SI B13 08 15
Fuel Systems

Service Action: S63 Engine – Check and Replace High-Pressure Injectors

E70 (X5M)

E71 (X6M)

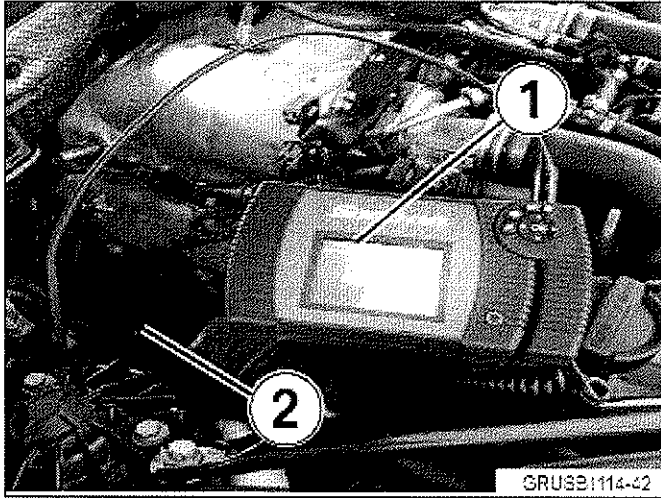
The high-pressure injectors may fail, resulting in an engine malfunction warning and reduced engine output.

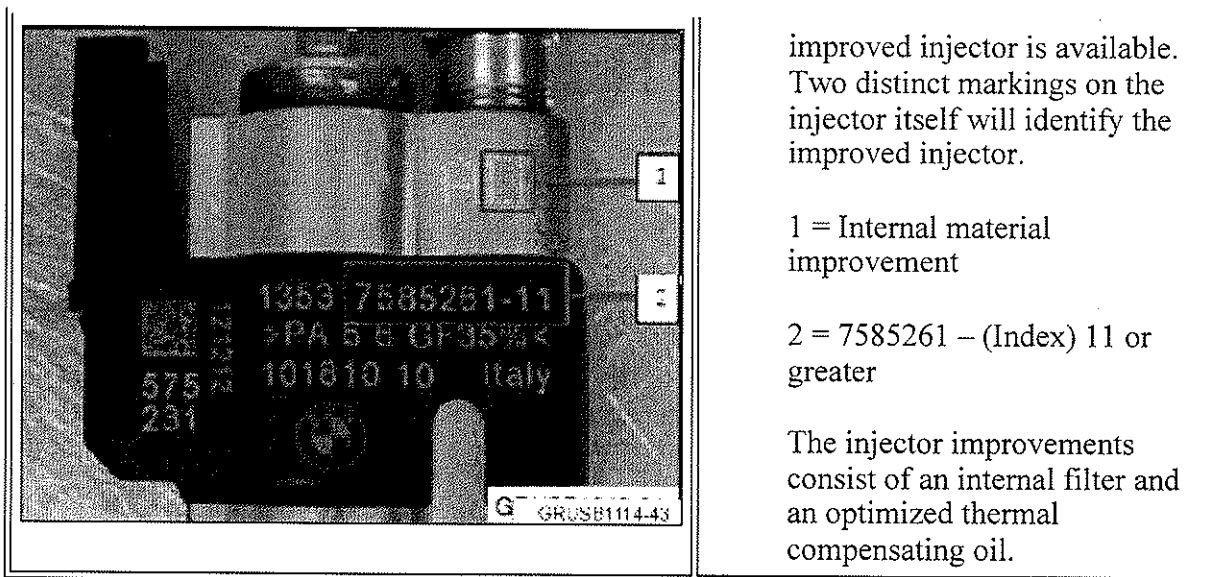
<ol style="list-style-type: none"> 1. Use a bore scope (1) or similar (mirror) to help identify the injector index number on the injector (2). <p>Do not remove the injector to identify the index number.</p>
	<ol style="list-style-type: none"> 2. Perform the injector index number evaluation on both cylinder banks. <p>As of January 2013, an</p>

improved injector is available. Two distinct markings on the injector itself will identify the improved injector.

1 = Internal material improvement

2 = 7585261 – (Index) 11 or greater

The injector improvements consist of an internal filter and an optimized thermal compensating oil.

- All injectors that are not index 11 or higher will need to be replaced. Use P/N 13 53 8 648 937 when replacing the injector(s).

If the injector index number is already 11 or greater, take no further action regarding injector repairs.

IMPORTANT: Injectors with index 11 and higher have a different calibration and construction than injectors with index 10 and lower. Due to this difference, injectors with index 11 and higher and injectors with index 10 and lower cannot be mixed on the same engine bank (i.e., cylinders 1-4 or 5-8).
